International Aero Engines

ENGINE - HP COMPRESSOR RING CASES - INTRODUCTION OF INTEGRAL HP COMPRESSOR  
CASES AND ROTOR PATHS

Aug. 9/99

**V2500-ENG-72-0343**

HP Compressor ring cases - Before alteration  
Figure 1

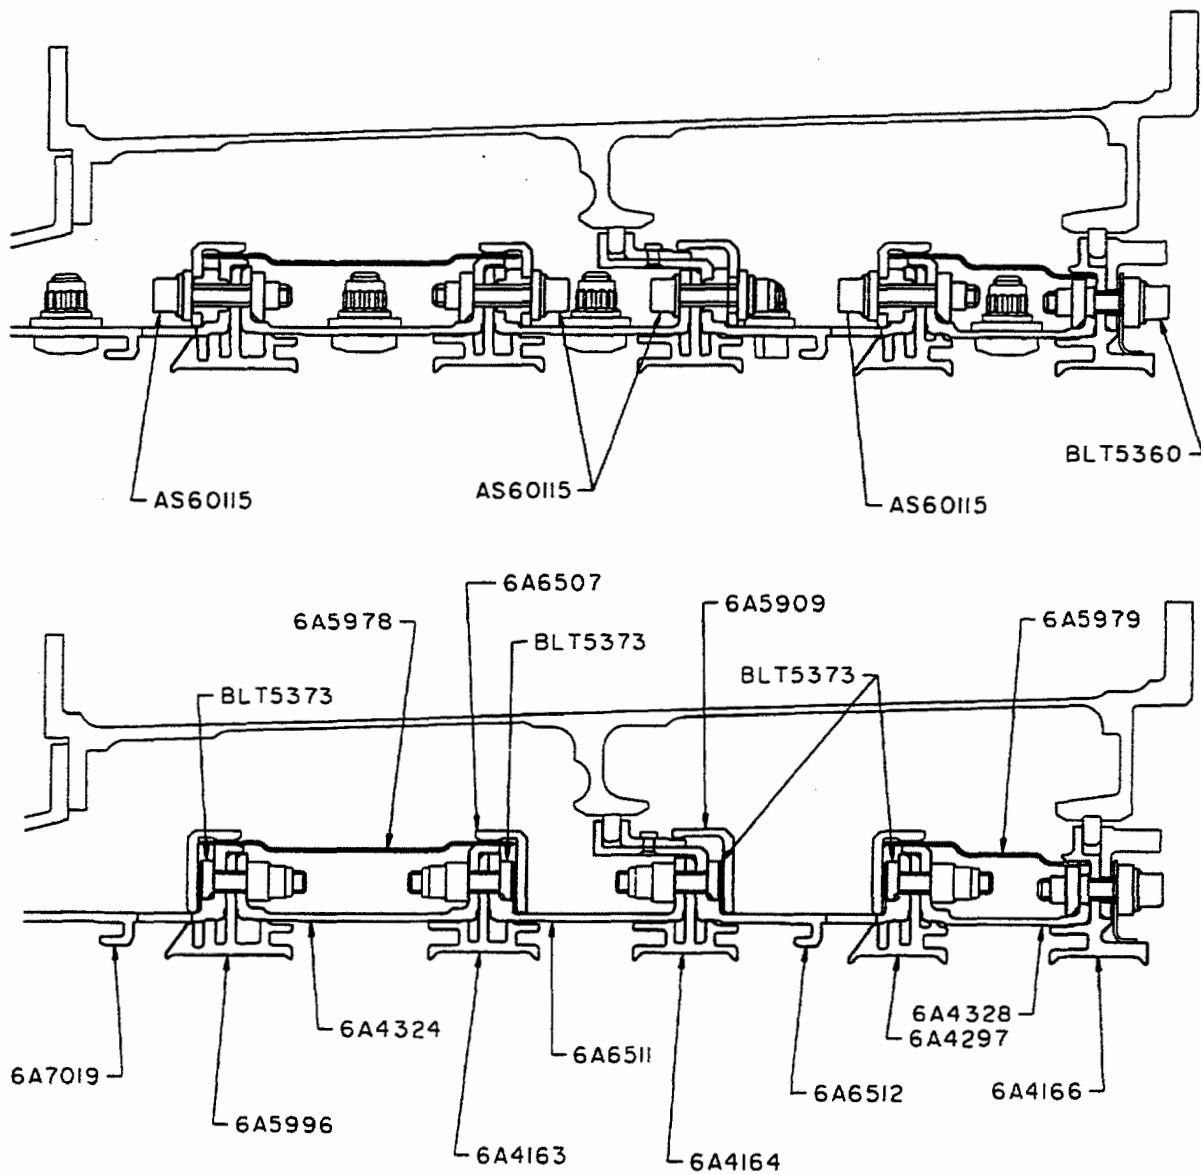
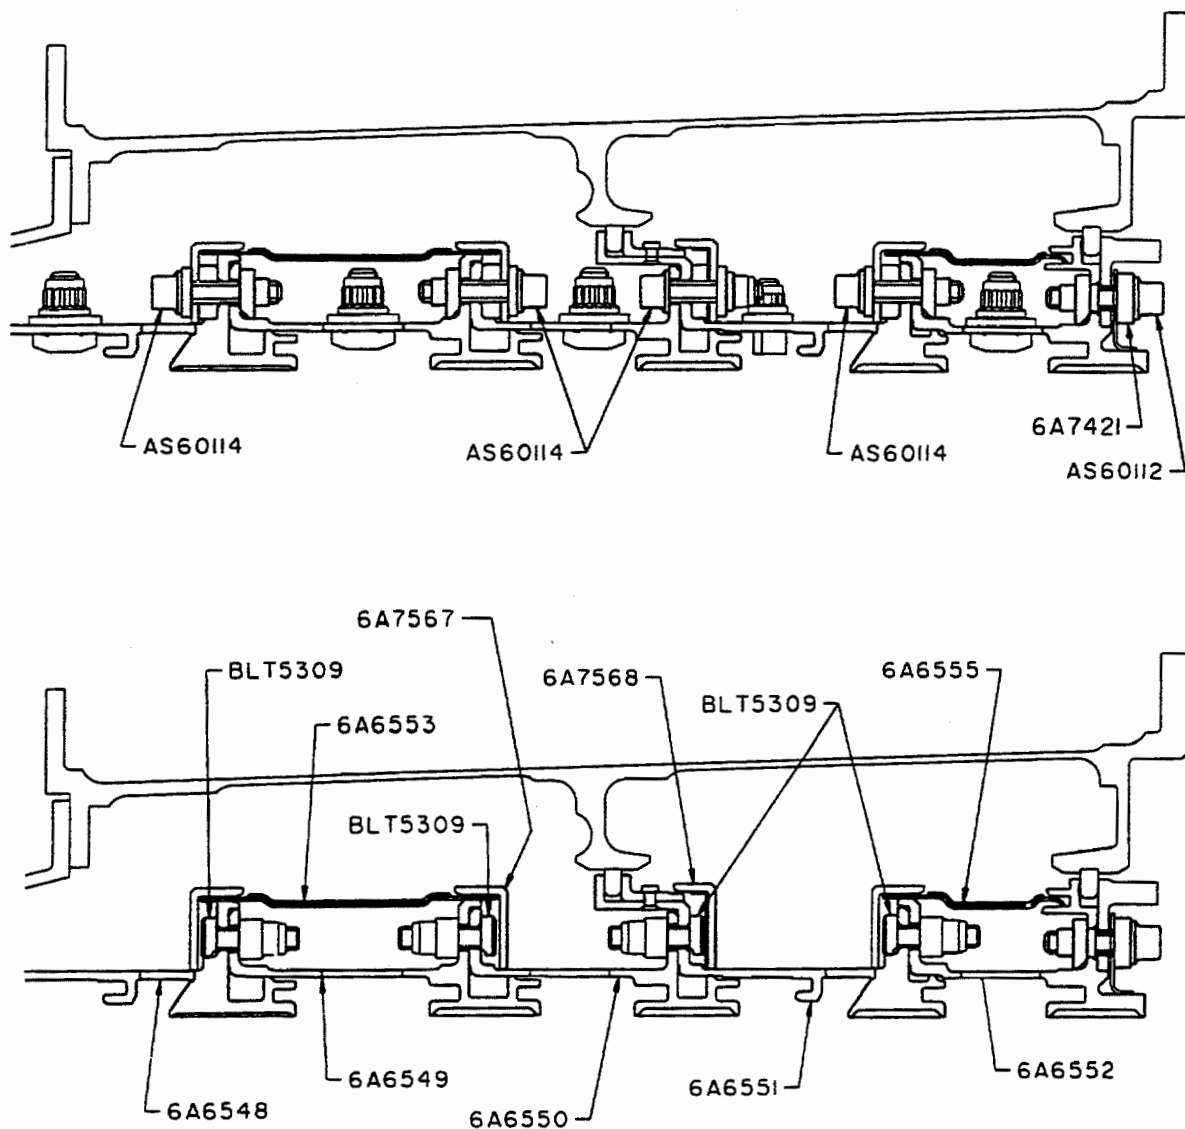
This modification introduces integral stages of the rear inner case and rotor path rings of the HP Compressor.

- (a) Integral Stage-8, 9, 10 and 11 case and rotor path assemblies are introduced to replace the separate case assemblies and rotor path rings.
- (b) An integral Stage-12 case and rotor path assembly is introduced to replace the separate case assembly and rotor path ring. The changes that follow are also included:

- (i) To provide sufficient clearance between the boss flange and the radius on the case, the intrascope boss has been moved 0,50 mm to the rear.
  - (ii) To locate the rear of the Stage-12 heat-shield, a bird mouth feature is introduced at the rear of the Stage-12 case and rotor path assembly.

- (c) The Stage-8 heat-shield assembly has been revised. The axial length has decreased.
- (d) The Stage 9 heat shield retainer assembly has been revised, to give an 8,00 mm clearance hole. This permits an extension of the anti-rotation pin in the Stage 9 HP Compressor casing assembly.

- (e) The Stage 10 heat shield retainer assembly has been revised,
  - (i) The axial length has decreased.
  - (ii) An 8,00 mm clearance hole is introduced. This permits an extension of the anti-rotation pin in the Stage 10 HP Compressor casing assembly.

- (f) The Stage-11 heat-shield assembly has been revised. The rear edge has becurled to match the bird mouth of the Stage-12 case and rotor path assembly

- (g) The special bolts which attach the cross key location ring to the Stage 12 case and rotor Path assembly are replaced by standard type bolts and washers.

- (h) The bolts which attach the heat-shield assemblies to the case assemblies have been revised. The length of the bolts has decreased.
